Nomad SERVICE BULLETIN

STRUCTURES GENERAL — FASTENERS — IMPROVED RIVETING OF SKINS (MODIFICATION N406 PART A)

NMD-51-1

Figure 1 Underside of the Left Wing

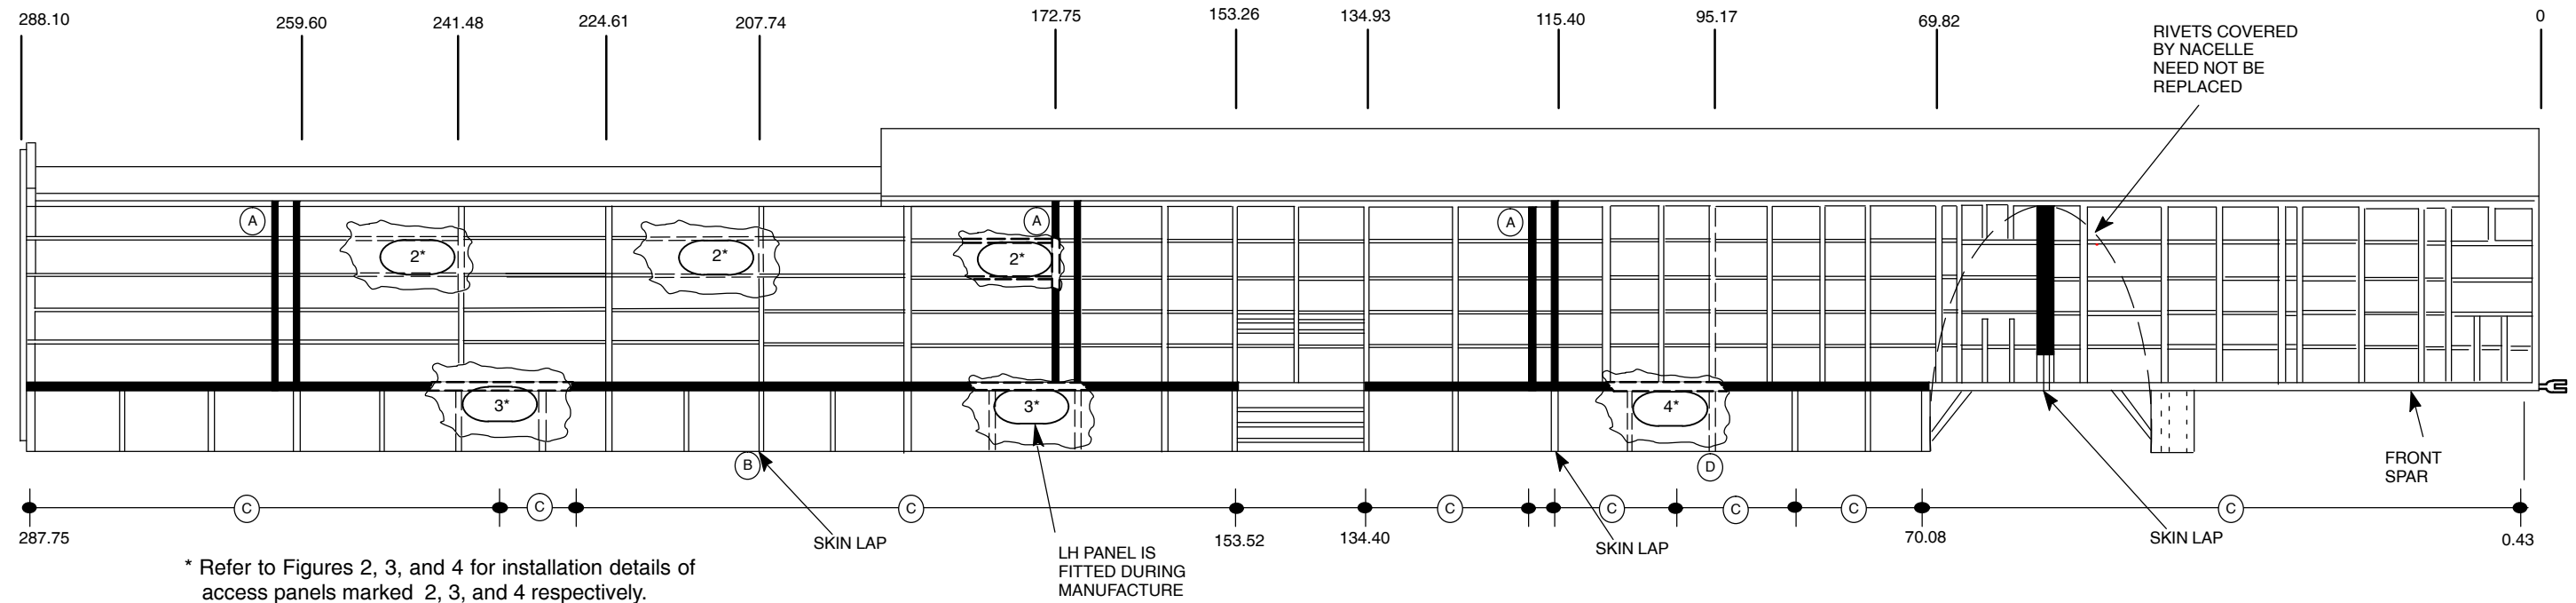
On the undersurface of the wings AGS 2050 rivets in the designated areas (Ref Fig 1) are replaced on a size-for-size basis with those nominated in Figure 1. Aircraft not fitted with the airframe de-icing option G18 (N22 Series) or G18-24 (N24 Series) and auxiliary fuel tank option G99 will require access panels to be installed in the wings to facilitate the rivet replacement. Solid rivets should be used in preference to cherry rivets, where access panels make this possible.

- (5) Replace the existing skin to spar cap AGS 2050 rivets as designated in Figure 1 on a size-for-size basis with the nominated cherry type rivets or the approved alternative (Ref Part 6).

- (9) Replace the existing AGS 2050 pop rivets, as designated in Figure 1 that are accessible through the access panels, with solid rivets P/N MS20470AD on a size-for-size basis. Replace the other rivets designated in Figure 1 with the specified cherry type rivet or the approved substitute (Ref Part 6).

- Outer skin removed for clarity.
- Where accessible through access panels outboard of WSTA 114.15, pop rivets AGS2050-4-BS may be replaced with solid rivets MS20470AD-4-(4), (5), & (6) in lieu of Cherry or Cherry Max rivets.
- CR3213, CR3243 and NAS1738E have alloy steel stems and require painting to prevent corrosion.
- Rivet quantity and length are indicative of those used on current production wings retro-fitted by this instruction. Variations from wing to wing may occur. Ensure correct length with rivet gauge.
- Assembly notes:
 - Wet assemble all components with jointing compound.
 - Prime and paint to suit aircraft.
 - Seal all access holes using PR1422 or PR1440.

- Apply wax release agent OP QV10 or QZ11B (CIBA GEIGY) over door contact area.
- Close doors to approx 0.020 in from fully closed position. Leave in this position to cure.
- When finally cured, trim sealing compound to suit. Close doors fully.

CODE	AREA	STATION POINT LOCATION	RIVET SPEC	QTY
(A)	RIVET SKINS TO DOUBLE RIB	115.40, 172.75, 259.60	CR3253-4-2	108
		172.75	CR3253-4-3	8
(B)	RIVET SKIN TO RIB	AT SKIN LAP 207.72	CR3253-4-2	51
(C)	RIVET SKINS TO SPAR	287.75 TO 247.40	CR3253-5-3	29
		245.99 TO 226.13	MS20470AD5-7	19
		224.91 TO 213.64	CR3253-5-3	9
		212.24 TO 191.17	CR3253-5-4	20
		190.06 TO 162.66	MS20470AD5-7	27
		161.64 TO 153.52	CR3253-5-4	9
		134.30 TO 114.45	CR3253-5-4	32
		113.66 TO 85.92	MS20470AD5-7	36
		85.12 TO 70.08	CR3253-5-4	20
		0.43	CR3253-5-4	1
(D)	RIVET L.E. SKIN TO L.E. RIB (FROM TOP TO BOTTOM)	ABOVE WING STATION 95.17	MS20470AD4-3	19
THE FOLLOWING RIVETS IN ORDER OF PREFERENCE MAY BE USED CR3243, NAS 1738E, NAS 1738B OR NAS 1738MW

Figure 2 Access Panel 2

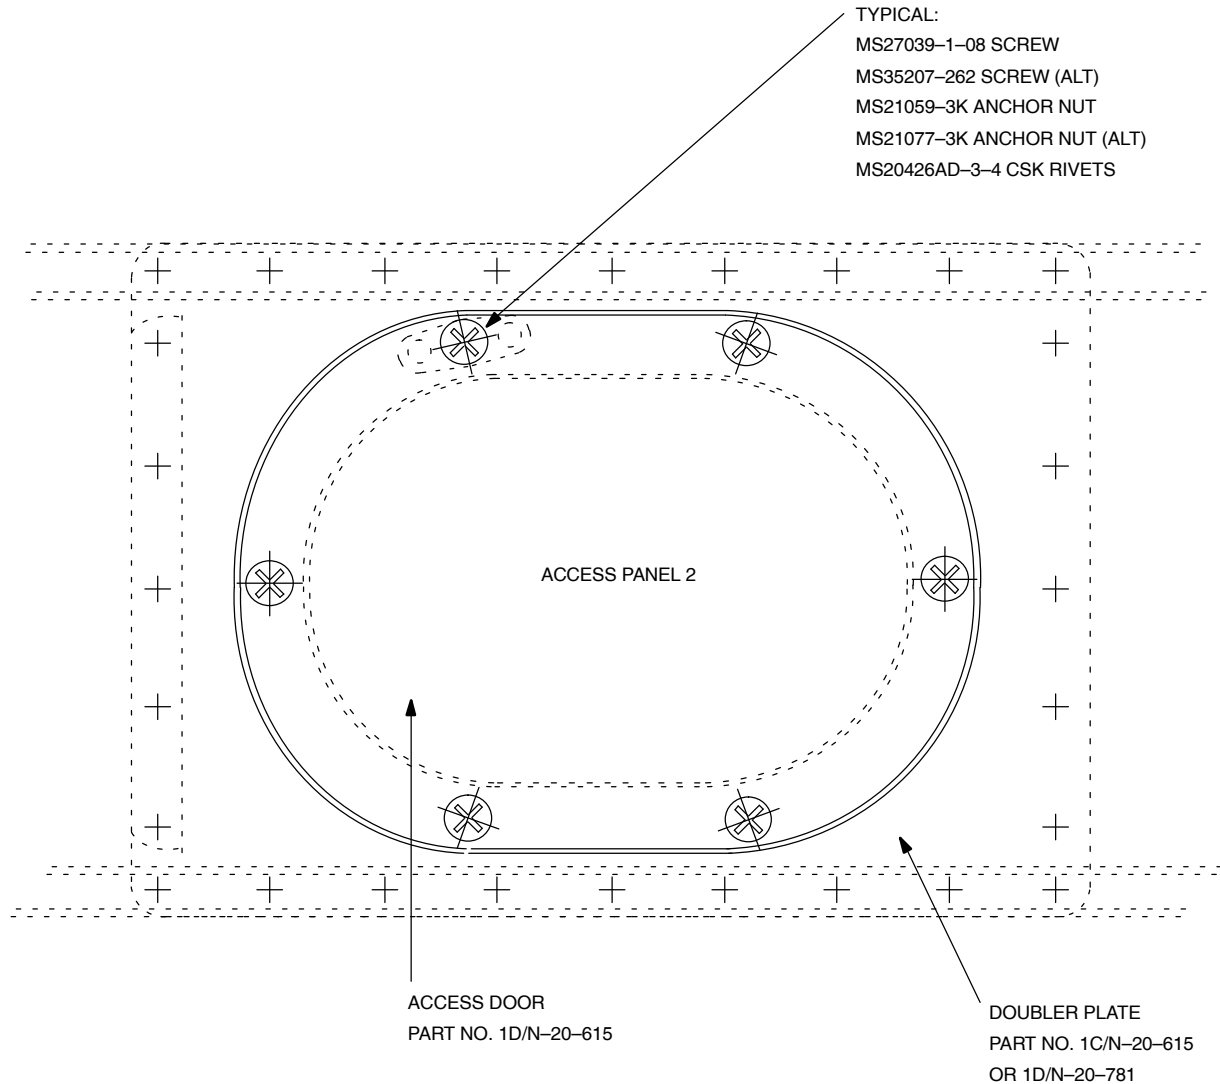
PICK UP EXISTING RIVET LOCATION.
REPLACE POP RIVETS WITH MS20470AD4-3 AND 4-4 AS REQUIRED.
DOUBLER PLATES TO BE INSERTED BETWEEN SKIN AND STRINGERS.
DOUBLERS MAY BE TRIMMED TO ACCOMMODATE LENGTH.

NOTE: AT WSTA 172.75 USE DOUBLER PLATE 1C/N-20-615
AT WSTA 207.74 AND WSTA 241.48 USE 1D/N-20-781.
EDGE TRIMMING OF DOUBLER PLATE IS PERMISSIBLE.

Figure 3 Access Panel 3

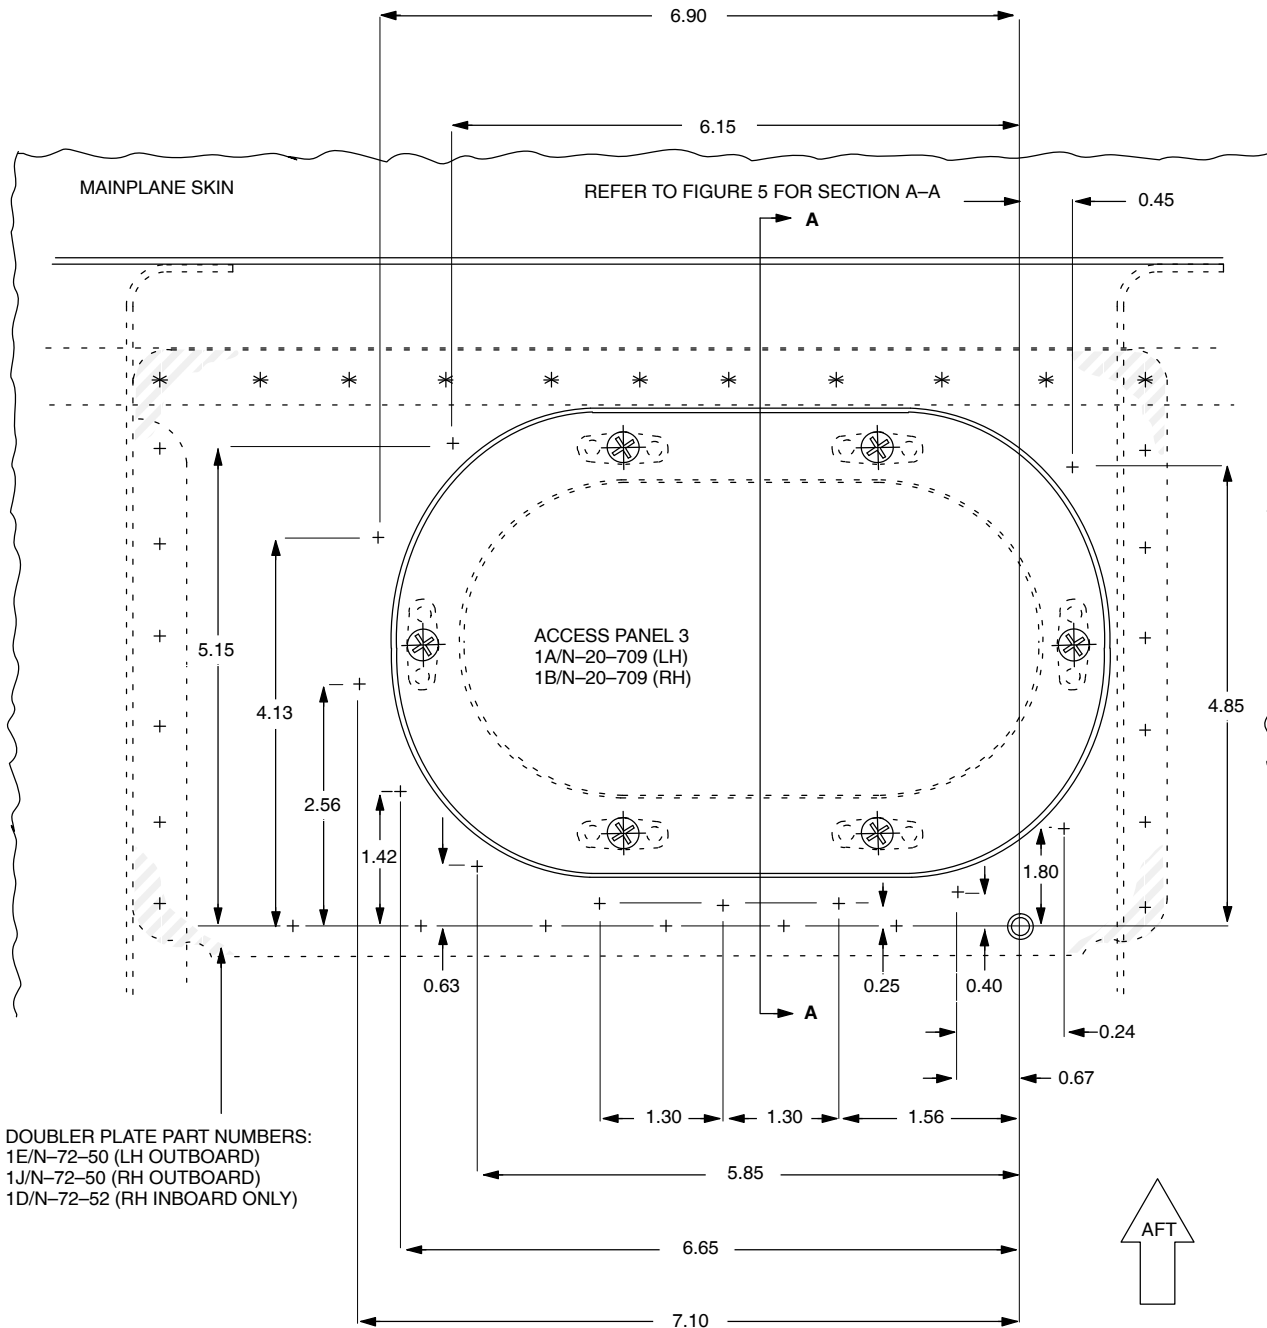
PICK UP EXISTING RIVET LOCATIONS AS SHOWN.
DOUBLER PLATES TO BE INSERTED BETWEEN SKIN AND STRINGERS.
DOUBLERS MAY BE TRIMMED TO ACCOMMODATE LENGTH.

USE MS20470AD4-3 AND 4-4 RIVETS AS REQUIRED

Figure 4 Access Panel 4

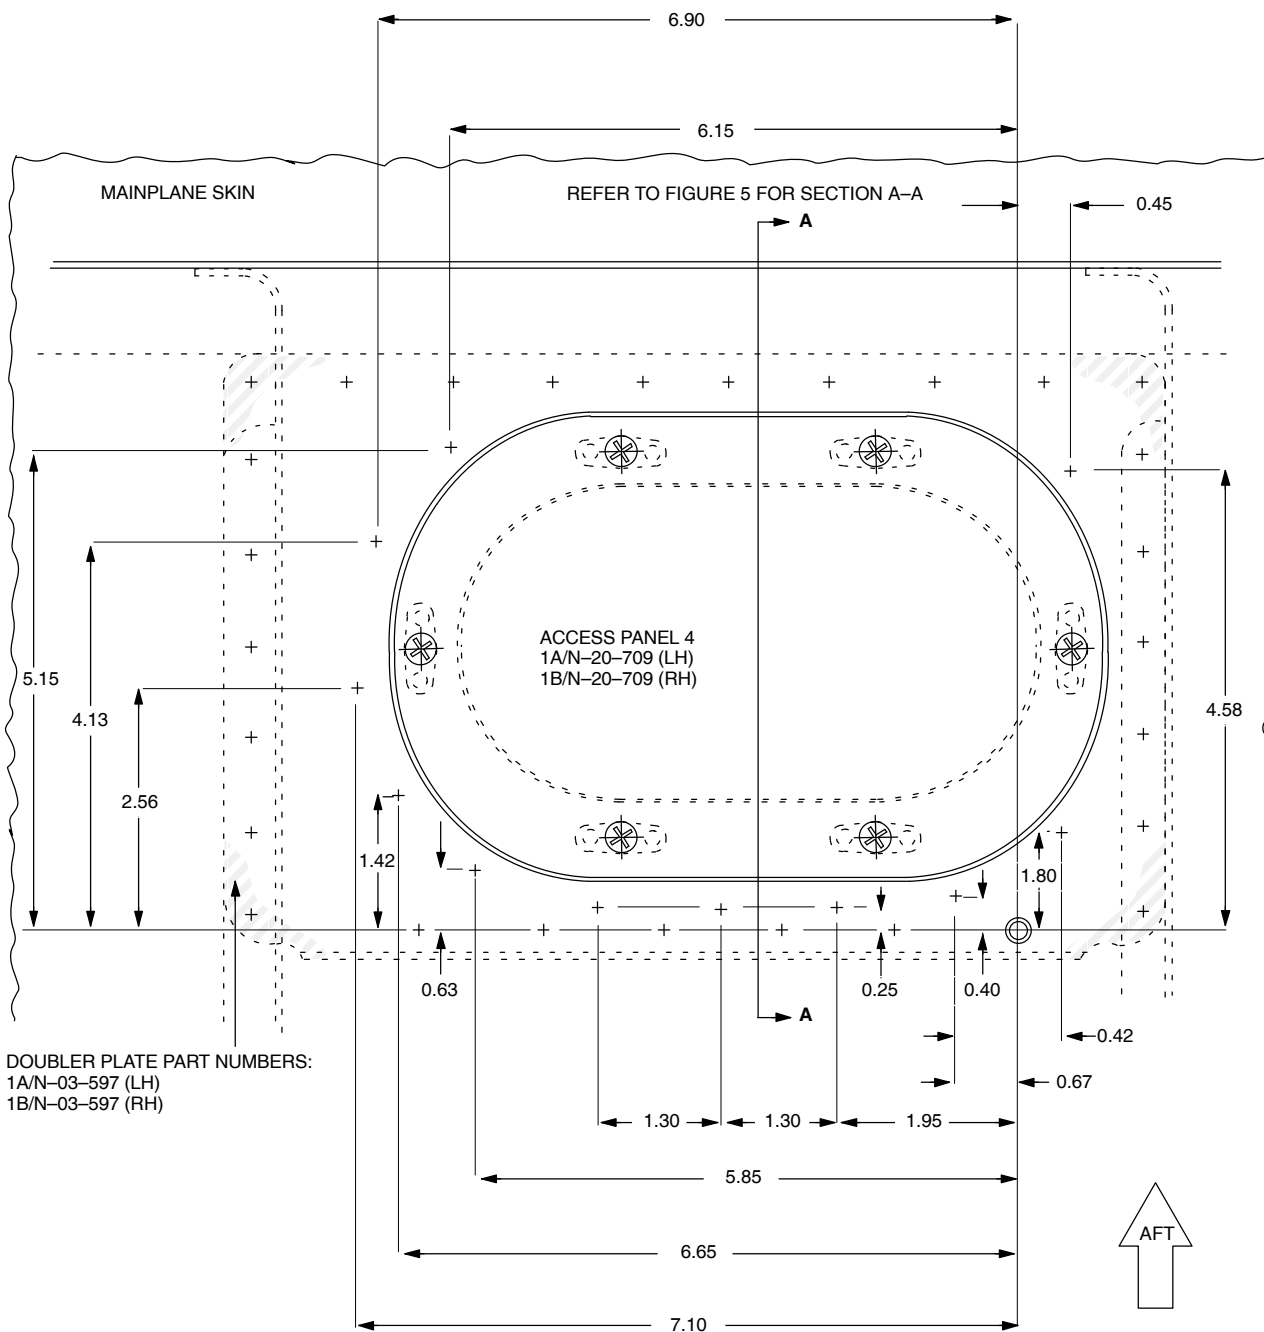
PICK UP EXISTING RIVET LOCATIONS AS SHOWN.
DOUBLER PLATES TO BE INSERTED BETWEEN SKIN AND STRINGERS.
DOUBLERS MAY BE TRIMMED TO ACCOMMODATE LENGTH.

USE MS20470AD4-3 AND 4-4 RIVETS AS REQUIRED

Figure 5 Access Panel Section A-A

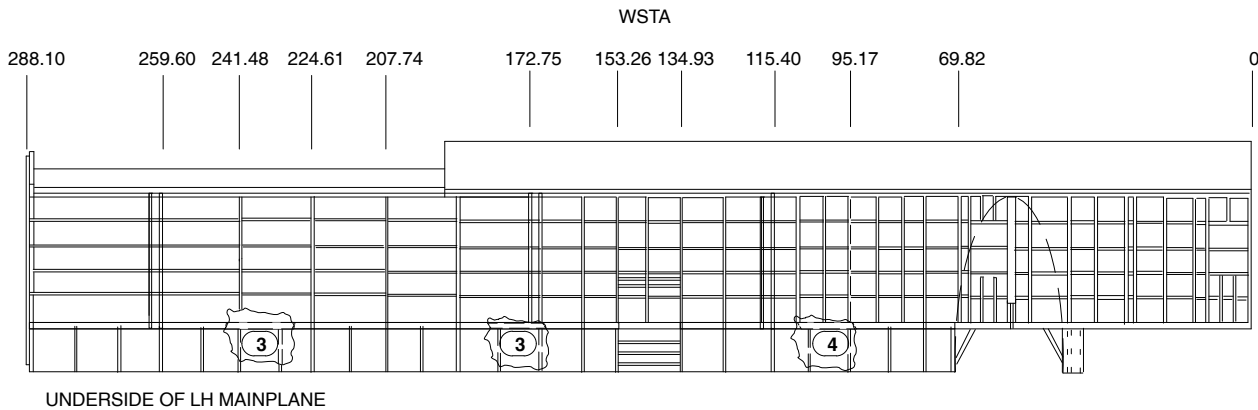
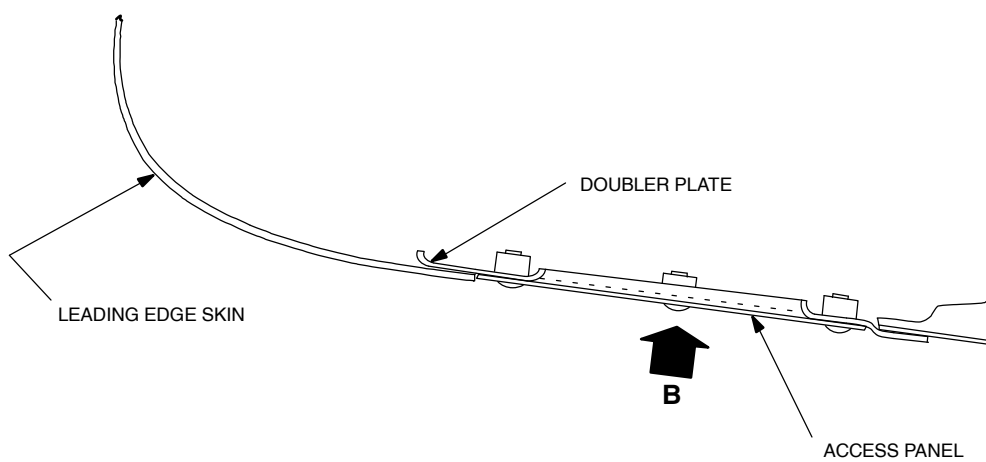
VIEW ON ARROW B SHOWING LOCATION OF LEADING EDGE ACCESS PANELS

Figure 6 Rudder Skin Rework

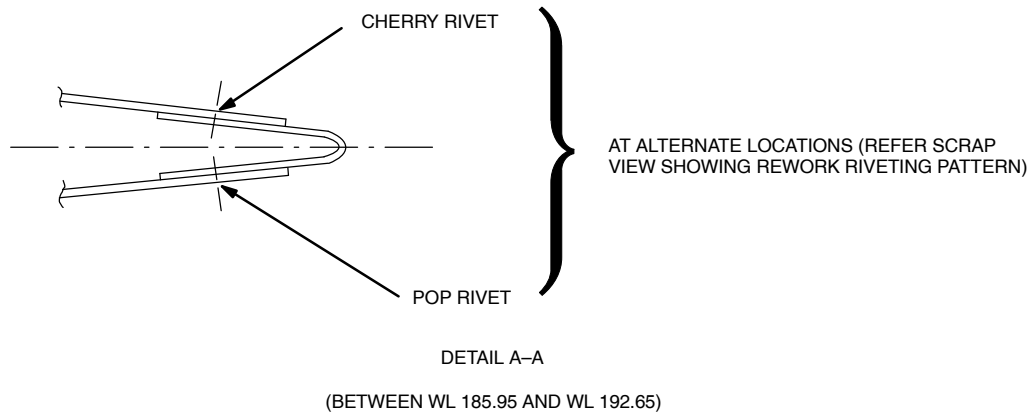
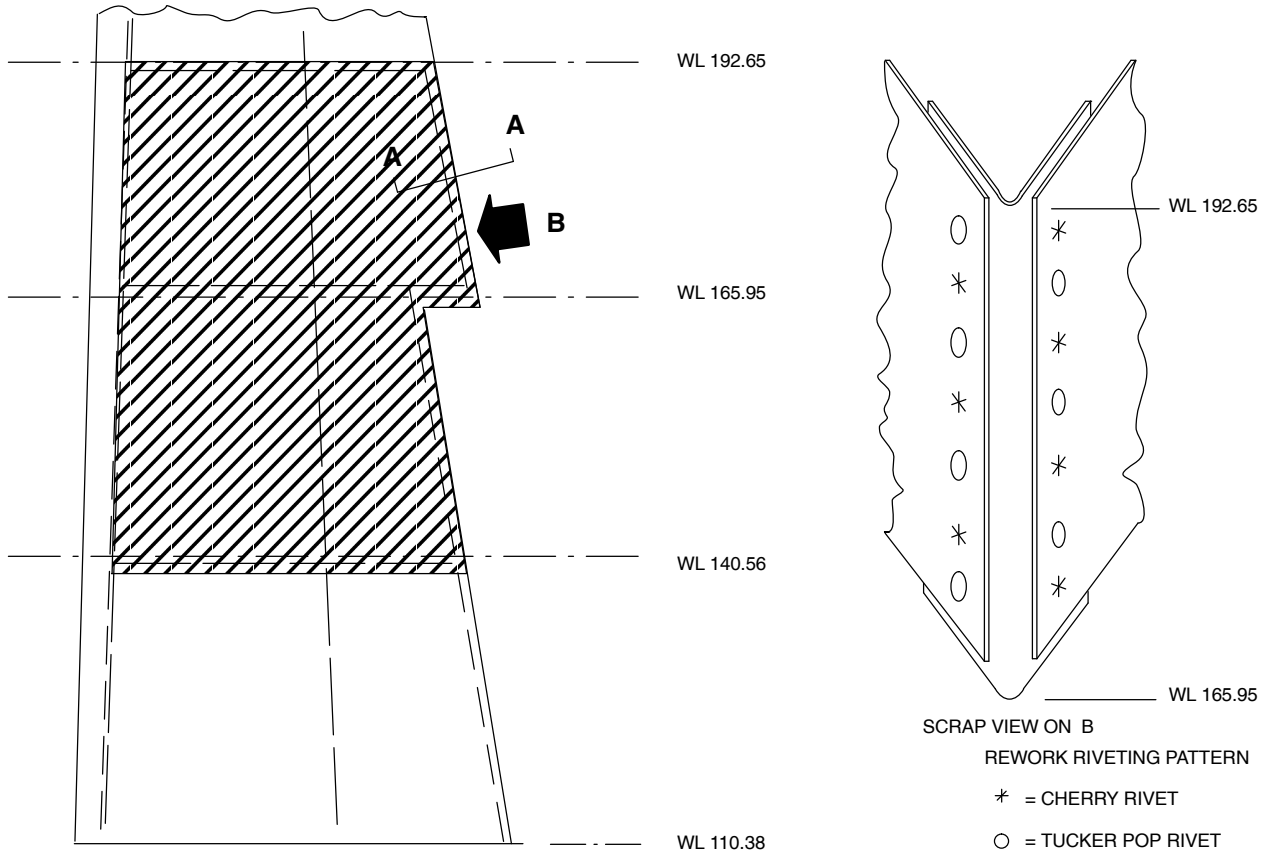
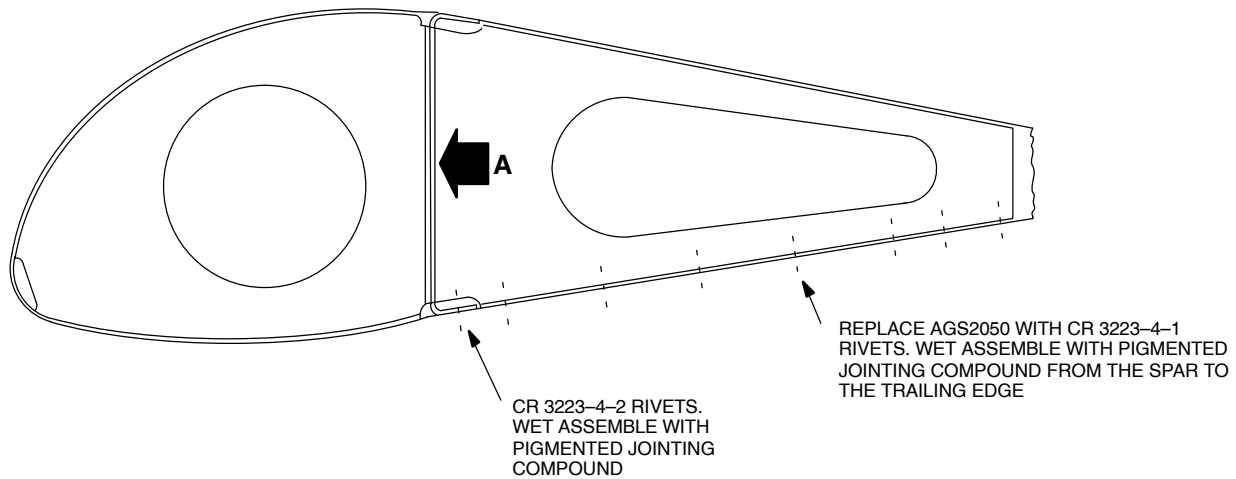
Replace the AGS 2050 pop rivets with CR 3223 cherry rivets or the approved substitute (Ref Part 6) on a size-for-size basis on and between rudder ribs between WLs 192.65 and 140.56 as shown in Figure 6 using the following procedure:

- (1) Rework only one face of the rudder at a time.
- (2) On the face being reworked (with the exception of the trailing edge between WLs 165.95 and 192.65 (Ref NOTE following step (4)) remove every second rivet and install the replacement cherry rivets.
- (3) After accomplishment of step (2) remove remaining AGS 2050 pop rivets from the face being reworked and install the replacement cherry rivets.
- (4) Repeat the rivet replacement procedure for the other face of the rudder.

- Along the trailing edge between WLs 165.95 and 192.65 ensure that the cherry rivets are installed opposite the AGS 2050 pop rivets on the first reworked face to obtain tail clearance between the two rivets (Ref Fig 6, Detail A-A and Scrap View on B).
- If either of the lower skins (between WLs 110.38 and 165.95 is removed to carry out other repairs, the AGS 2050 pop rivets in the installed lower skin may be replaced with solid rivets P/N MS20470AD on a size-for-size basis. The removed skin is to be installed using CR 3223 cherry rivets or the approved substitute (Ref Part 6) on a size-for-size basis.

IN SHADED ZONE REPLACE POP RIVETS WITH CHERRY RIVETS
CR 3223-4-1 AND CR 3223-4-2 WET ASSEMBLE USING JOINTING
COMPOUND.

Figure 7 Flap and Flap/Aileron Skin Rework

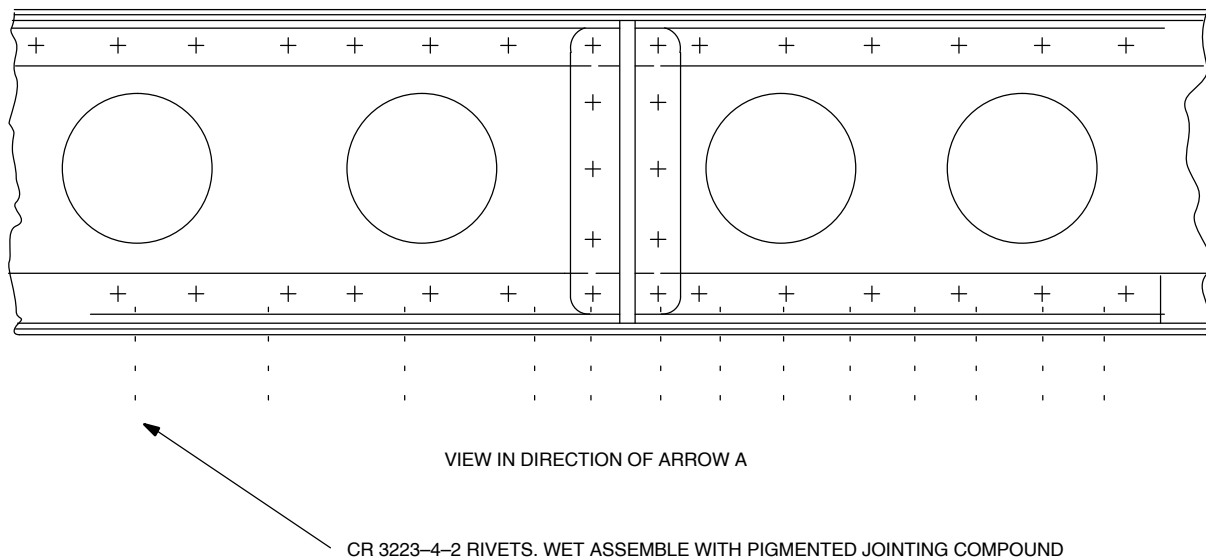
- (2) Replace the AGS 2050 pop rivets in the lower flap and flap/aileron panel surface as designated in Figure 7 with CR 3223 cherry rivets or the approved substitute (Ref Part 6) on a size-for-size basis.

TYPICAL RIVET CALL-UP: SKIN TO RIB AND SKIN TO BOOM
